***ACRS MEETING WITH  
THE U.S. NUCLEAR  
REGULATORY  
COMMISSION***

***November 5, 2010***

# ***Overview***

# Schematic of ESBWR Containment

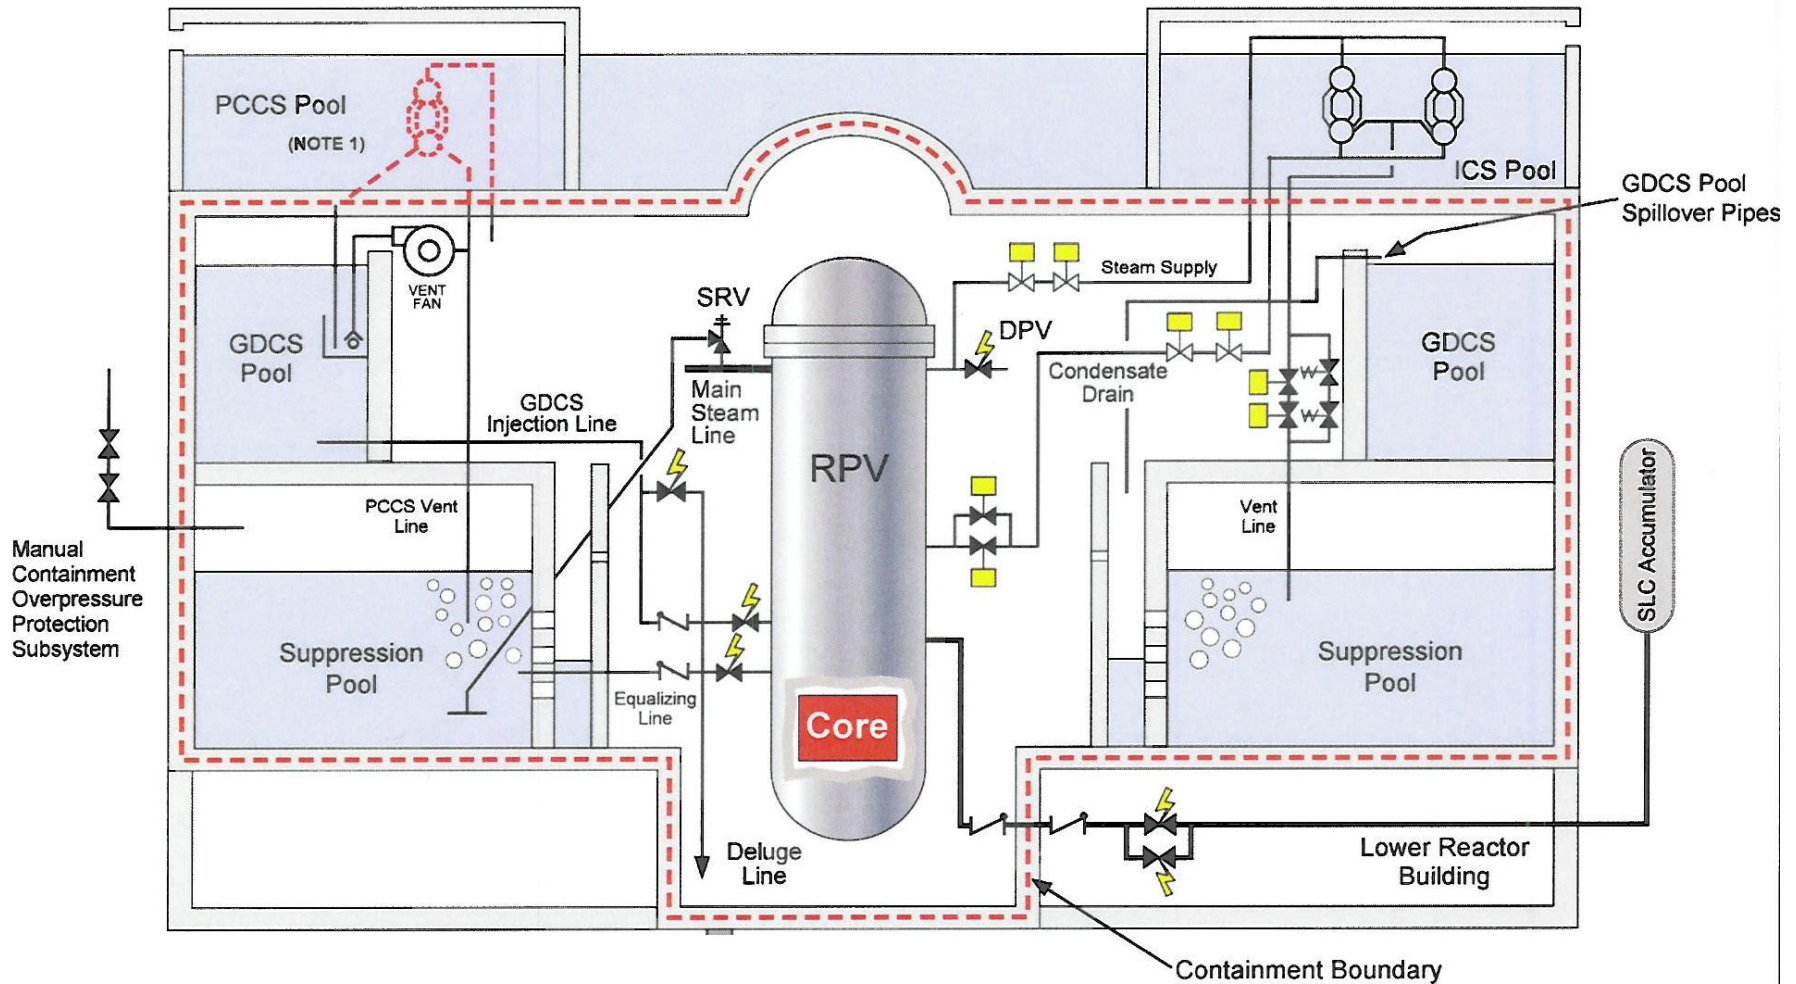
- ***The ESBWR design has a long-term core cooling mode that is qualitatively different from current reactors, since its passive safety systems can respond to a design basis accident without recirculation through the suppression pool.***

- ***The generic issues that have normally raised concerns for long-term core cooling in a recirculation mode for the ECCS are not present in this design because of the following:***

- No fibrous insulation is used in the plant design, all containment surface coatings are qualified, and no complex water chemistry is present.***

- The debris which reaches the suppression pool is not transported to the PCCS. The recirculation cooling path for long-term core cooling is wet steam into the PCCS, condensate from there to the Gravity-Driven Cooling System, and then back to the reactor vessel.***

- ***ACRS concurs with the staff's assessment that the regulatory requirements for long-term core cooling for design basis conditions have been adequately met and this issue can be closed for ESBWR***
